Product Change Notification

1. ECR #: 208864
Notification #: 613

- MEC6 - .635mm RIGHT ANGLE EDGE CARD ASSEMBLY

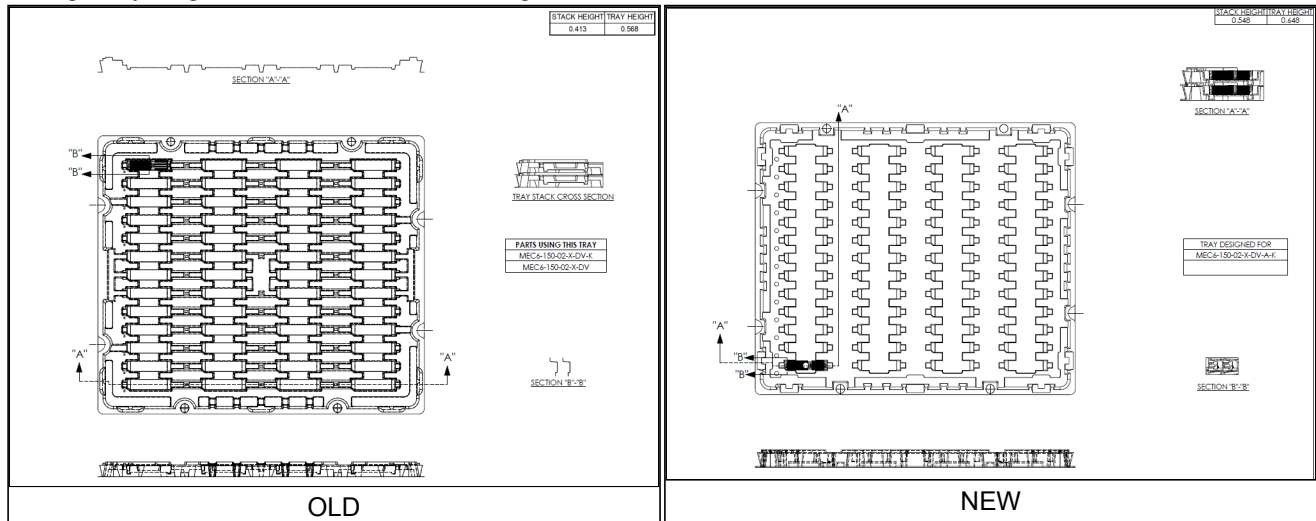
5. Description of Change:
Tray height has been modified

6. Method of Identifying Change
Change tray height .568" to .648" & stack height .413" to .548"

7. Reason for Change:
Changes are being made to improve the manufacturability

- Fit - Tray height & stack height
